Request	-	Special Use Permit for a New Gas Station
Location	-	3837 Secor Road
Applicant / Developer	-	Skilkengold Development, LLC 4270 Morse Rd Columbus, OH 43230
Owner	-	Sheetz, Inc. 5700 Sixth Ave Altoona, PA 16602
Engineer	-	Mannik & Smith Group 1160 Dublin Road, Suite 100 Columbus, OH 43215

The staff recommends that the Toledo City Plan Commission recommend disapproval of SUP-5009-24, a Special Use Permit for a new gas station at 3837 Secor Road, to the Toledo City Council, for the following five (5) reasons:

SPECIAL USE PERMIT  
TOLEDO CITY PLAN COMMISSION  
REF: SUP-5009-24  
DATE: August 8, 2024  
TIME: 2:00 P.M.

SITE PLAN

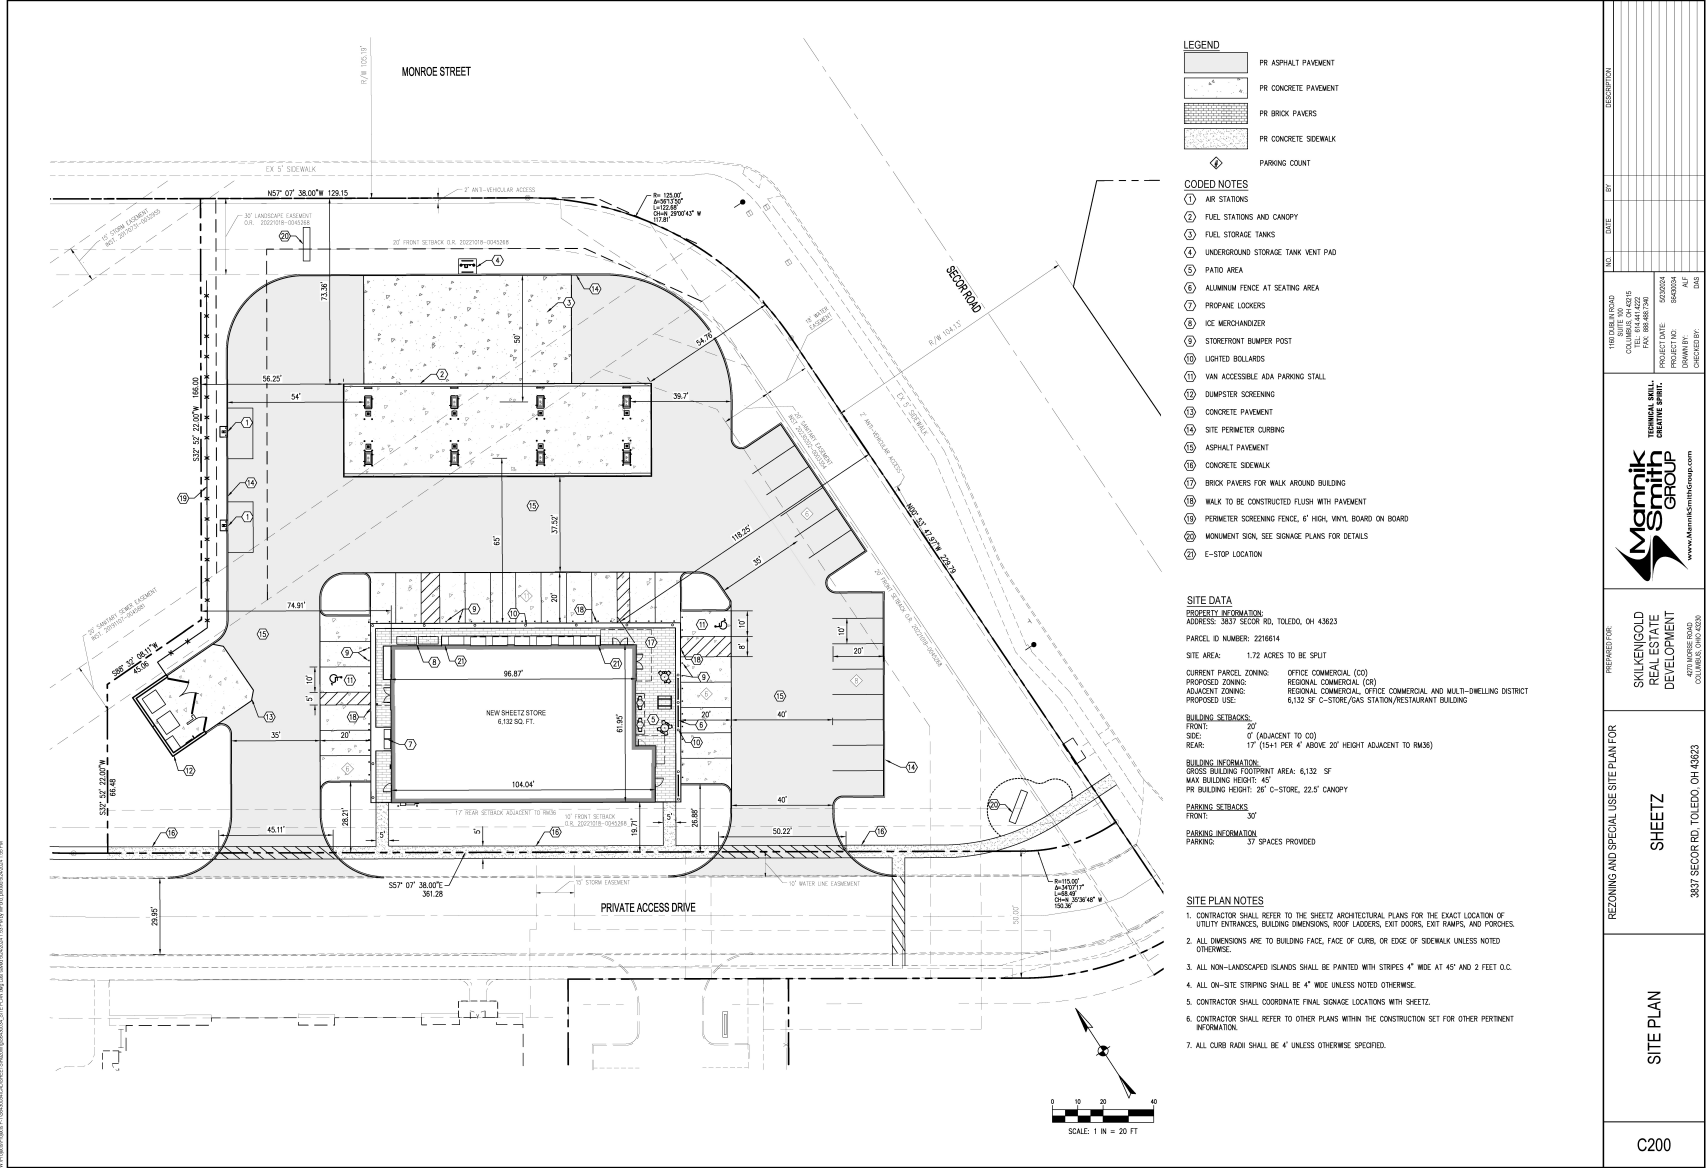
A front yard setback must be provided along private access drives. Per TMC§1106.0102, a front yard setback of twenty feet (20') is required. A setback of 19.71 feet is provided along the private access drive. A revised site plan showing compliance with this setback shall be provided. This has been listed as a condition in Exhibit "A".

This property has been recorded as part of a plat titled Secor Crossings. The Secor Crossings plat shows a landscape easement of thirty feet (30') along the rights of way of Monroe Street and Secor Road. The site plan shows this easement along Monroe Street, but does not show it along Secor Road. As a result, the parking lot encroaches into the easement by ten feet (10'). A revised site plan showing this landscape easement free of encroachments shall be provided. This has been listed as a condition in Exhibit "A".

TMC§1107.1600 *Vehicle Stacking Areas* outlines design standards for gas pump stacking spaces. A revised site plan showing required stacking spaces shall be provided. This has been listed as a condition in Exhibit "A".

A minimum of one (1) bicycle parking space per ten (10) automobile parking spaces is required pursuant to TMC§1107.0300 *Off-Street Parking Schedule "A"*. The site plan provides zero (0) bicycle parking spaces and is therefore not in compliance. Five (5) spaces are required and shall be provided on a revised site plan. Bicycle parking must be well-lighted, paved, and drained to be reasonably free of mud, dust, and standing water. These have been listed as conditions in Exhibit "A".

32. Bicycle parking is required per TMC§1107.0900.
33. Gas pump stacking is required to be shown per TMC§1107.1601.
34. Accessible parking signage is required to be shown and must comply with TMC§1107.1704
35. Gas pumps must be moved 3' to the northeast to allow room for a two-way drive aisle with the gas pump stacking per TMC§1109.1911 (25' drive aisle is required for two-way traffic).
36. A smaller radius of the parking lot northeast of the gas pumps is required to prevent a pinch point of traffic flow.

- a. A twenty-foot (20') front yard setback shall be provided along the private access drive. **Not acceptable as depicted. A revised landscaping plan shall be submitted depicting the twenty-foot (20') front yard setback along the private drive.**

- b. Stacking spaces required by TMC§1107.1600 *Vehicle stacking areas* shall be depicted. Stacking spaces shall show compliance with TMC§1107.1600. **Not acceptable as depicted.**

- a. A 5-foot-wide connecting walkway shall be provided from at least one main entrance to the intersection of Monroe Street and Secor Road without requiring pedestrians to walk around buildings or around parking lot outlines which are not aligned to a logical route. **Not acceptable as depicted. A revised site plan shall be submitted depicting a connecting walkway to the intersection of Monroe and Secor.**

- 50. Two (2) speed tables shall be required on the private access drive. Locations shall be approved by the Division of Traffic Management and the Director of the Toledo City Plan Commission. **Not acceptable as depicted. Speed tables in approved locations shall be depicted on a revised site plan.**

# STORE LANDSCAPE PLAN

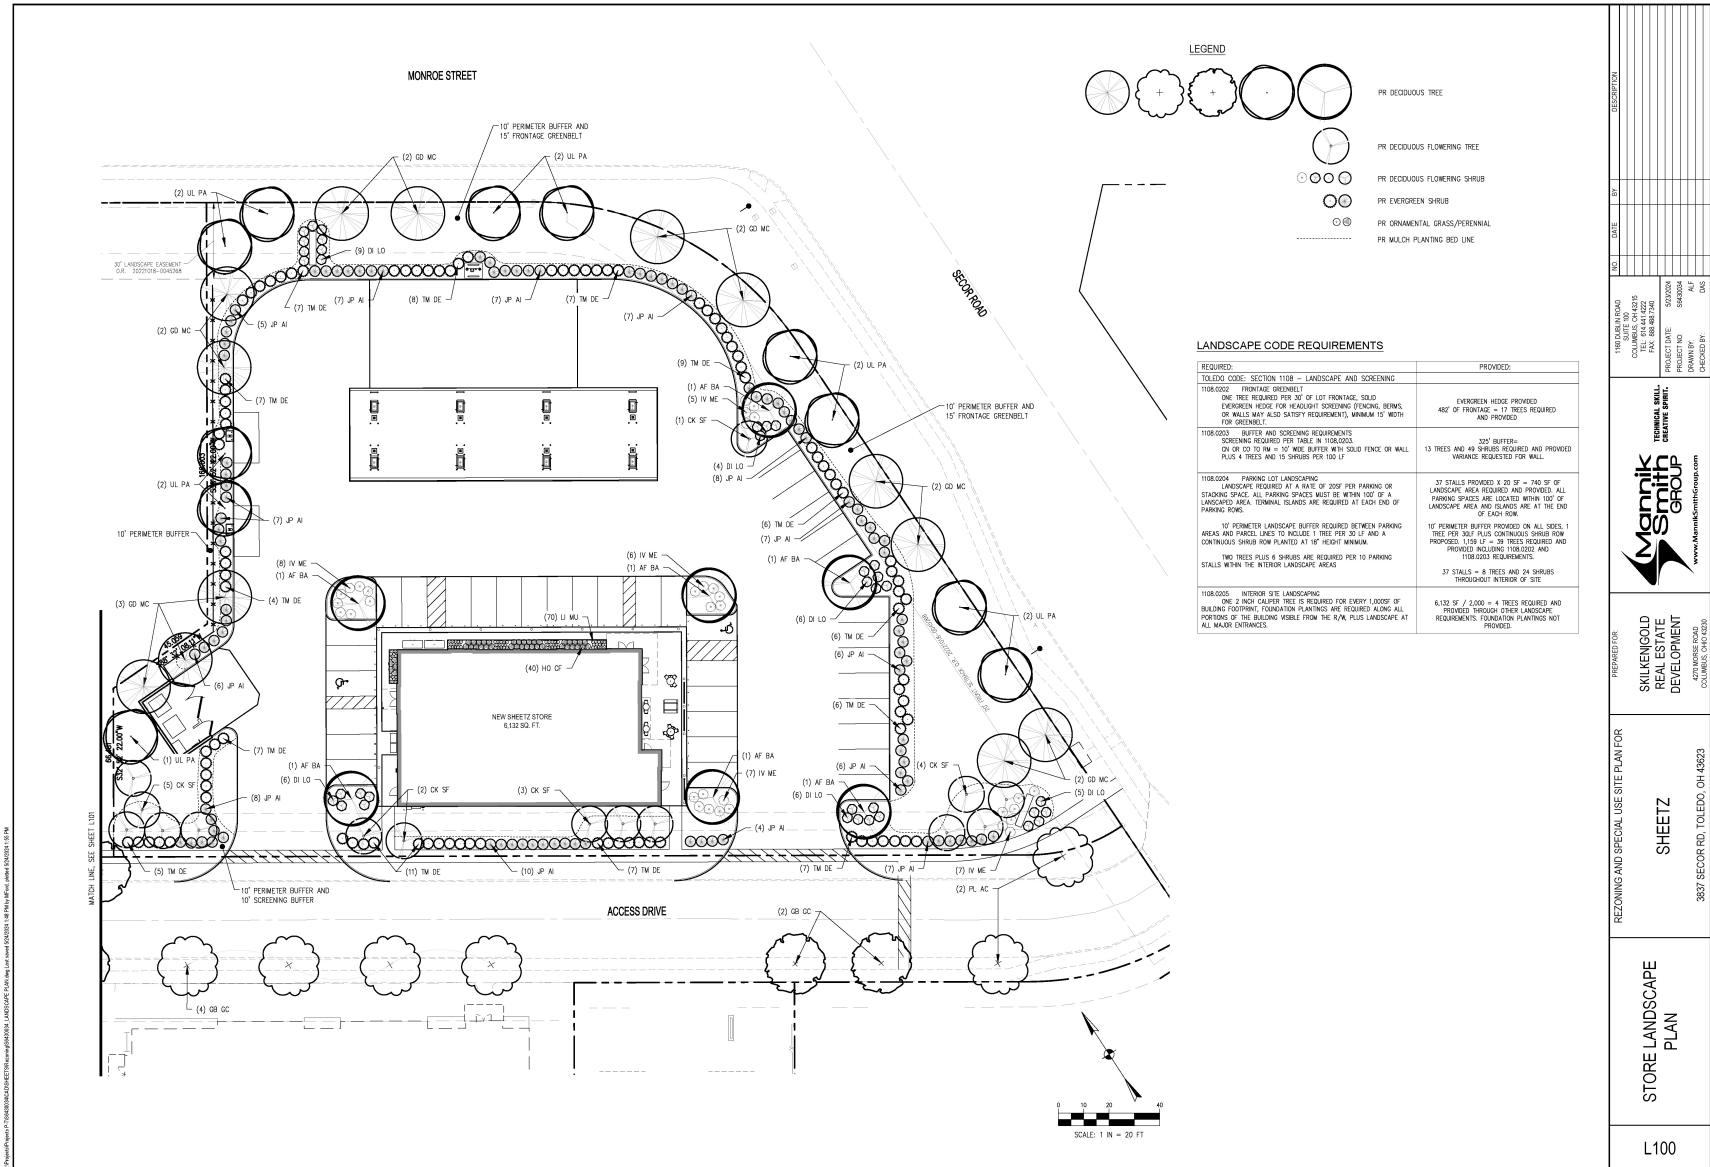
TMC§1108.0204(C)(1) *Interior* requires two (2) canopy trees and six (6) shrubs in the interior of parking lots for each ten (10) parking spaces, rounded up. The site plan provides forty-five (45) parking spaces, meaning ten (10) trees are required in the parking lot interior. However, the submitted landscaping plan depicts only eight (8) trees in the parking lot interior. Two (2) additional trees are required and shall be provided. This has been listed as a condition in Exhibit “A”.

- e. Two (2) canopy trees and six (6) shrubs are required to be installed in interior landscape areas for each ten (10) parking spaces within the parking lot. A total of ten (10) trees and thirty (30) shrubs are required for this site. **Not acceptable as depicted. Two additional trees required and shall be shown on a revised landscaping plan.**

- g. Foundation plantings shall be required along the portions of the building visible from the right-of-way. **Not acceptable as depicted. Foundation plantings shall be provided along eastern and southern façades and shown on a revised landscaping plan.**

REAR & RIGHT ELEVATIONS

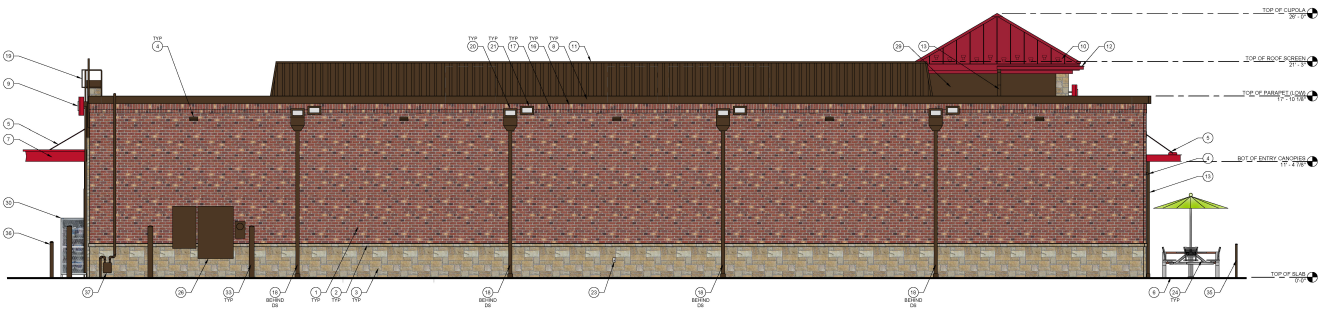
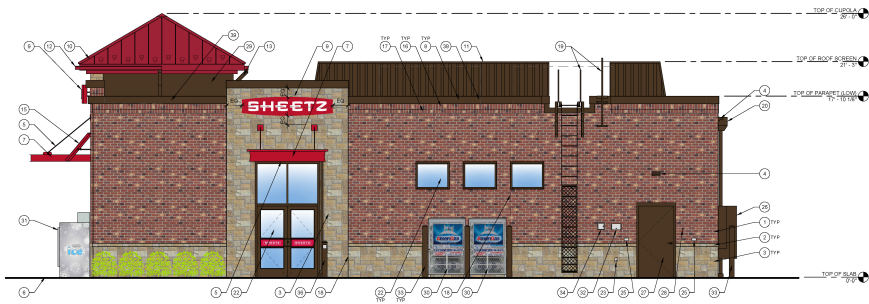
The southern elevation – named the “rear” elevation on the submitted building elevations – faces the senior apartments and pedestrian walkways shown to the south, yet it lacks pedestrian orientation or character. In fact, it lacks any design characteristics consistent with those on the primary façade as required in TMC§1109.0204 & 1109.0205. While the other façades come closer to compliance with the section, they are still missing some variation in massing. As stated in TMC§1109.0205(B)(3), building design that is based on a standardized formula associated with a business or franchise shall be modified if necessary to meet the Design Standards. The proposed building is clearly based upon a standardized formula which has been superimposed onto the site and it is unresponsive to its context near residential apartments in the neighborhood’s park-like setting. The proposal does not meet the stated purpose of these design standards. Revised building elevations shall be submitted in compliance with TMC§1109.0204 & 1109.0205 and listed as a condition in Exhibit “A”.

- b. Southern or “rear” elevation shall be redesigned to be responsive to its context and meet the provisions of TMC§1109.0205 *Building Design Standards*. **Not acceptable as depicted.**

- c. The building design shall provide a well-defined top by using features such as distinct and multiple architectural roof forms, clearly pronounced eaves, and/or distinct parapet designs and cornice treatments. **Not acceptable as depicted on southern or “rear” elevation.**
